# Bulletin

**SUBJECT:** FLX-4000™ (Dialight®) 12” LED Flashing Light  
Assembly 042975-7

**NO:** 1-06

**CONCERN:** Incorrect component causing false activation of the  
highway crossing warning signals

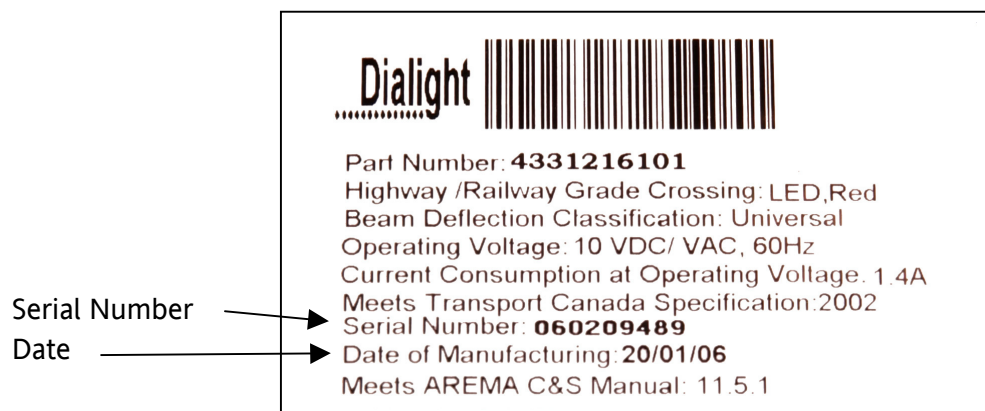
The last five digits of the serial numbers for the affected FLX-4000™ LED assemblies range from 05228 through 06031. These units were manufactured between 16 August 2005 (16/08/05) and 31 January 2006 (31/01/06). The serial number and date of manufacture information is located on a white label attached to the back of each FLX-4000™ assembly. A sample of the label is shown below.
